MEMORANDUM

Subject: RZN 22-0002/ORD 1994-Request to rezone 3.08 acres at 1800 Whipple Drive (Tax Map

Nos.197-1 50A, 51C, 5; 197-a 51B, 52B, 5; 197-1 51A, 52A, 5; 167-24 53A and 197-1 46A) from R-5 Transitional Residential to PR Planned Residential by Balzer and Associates

PLANNED RESIDENTIAL DEVELOPMENT
PROPOSED SHARED PUBLIC UTILITY EASEMENTS

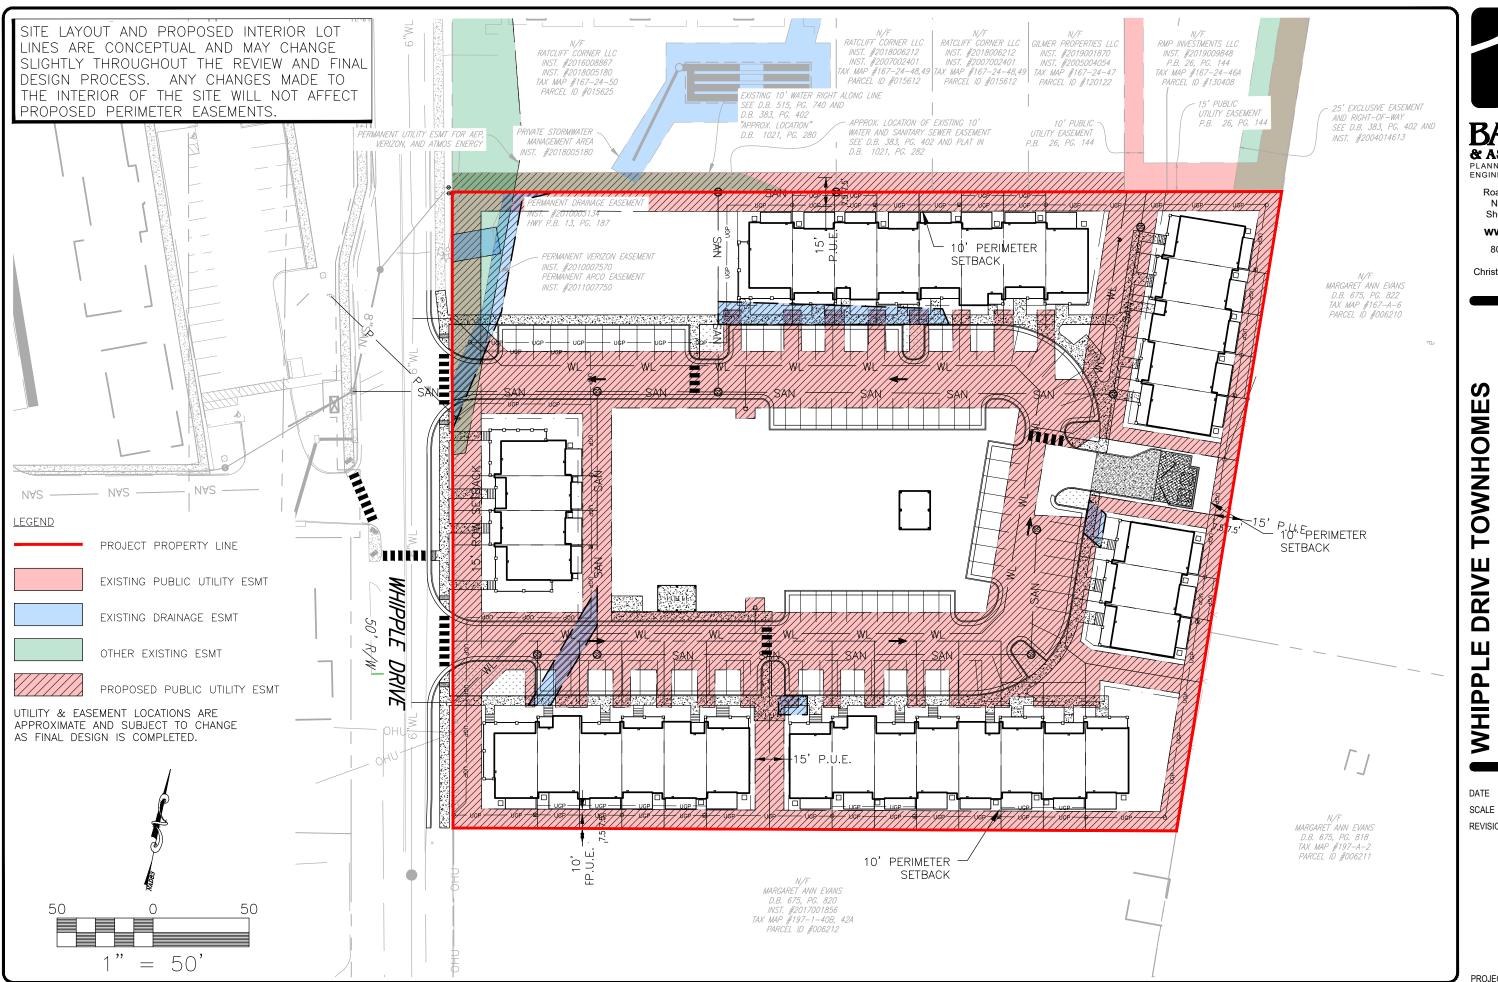
The applicant has not revised the plan to provide the required minimum 15' perimeter PUE. The August 18, 2022 utility easement exhibit shows a continuous 10' PUE around the perimeter of the property, as well as interior PUEs around the proposed public utilities for the development. *The applicant is requesting a variance to Subdivision Ordinance Standard §5-901 to reduce the width of required public utility easements from 15' to 10'.*

The request to eliminate required width in public utility easements, and to layer landscaping, rear yards, and the PUEs is to support the applicant's desired increase in density and proposed layout to maximize the number of units. For new development, there is no reason that this minimum development standard cannot be met. Staff does not support the request to reduce the required perimeter public utility easements from 15' to 10'.

The revised application also now shows that a 10' easement is proposed on three adjacent properties owned by Ratcliff Corner, LLC, to the north of the subject parcel. Two of these parcels are undeveloped, while one is developed with the Ratcliff Corner (RC) Townhomes. The RC Townhomes were developed with a conditional use permit in 2018. There was no perimeter public utility easement required, because the property was not subdivided. The three other adjacent parcels to the north owned by Gilmer Properties LLC currently have an existing 15' wide perimeter public utility easement along the

Staff and the Town Attorney have concerns regarding the commitment and enforceability of this proposal to use adjacent properties for required PUEs. The applicant provided an unsigned agreement that their attorney has drafted for the adjacent property owners to sign as commitment of intent to dedicate the easements. The agreement was provided to staff under separate cover from the revised application and is attached to this memo. The document that was provided is a memorandum of understanding, which is a statement of intent by JJB properties and landowners adjoining JJB's Whipple Drive property to grant each other a ten foot public utility easement ("PUE") along the borders of their properties. The MOU does not state when that the dedication will occur. More details, such as details about what will be permitted in the PUE and what role the Town has (typically PUEs are dedicated to the Town), will be needed.
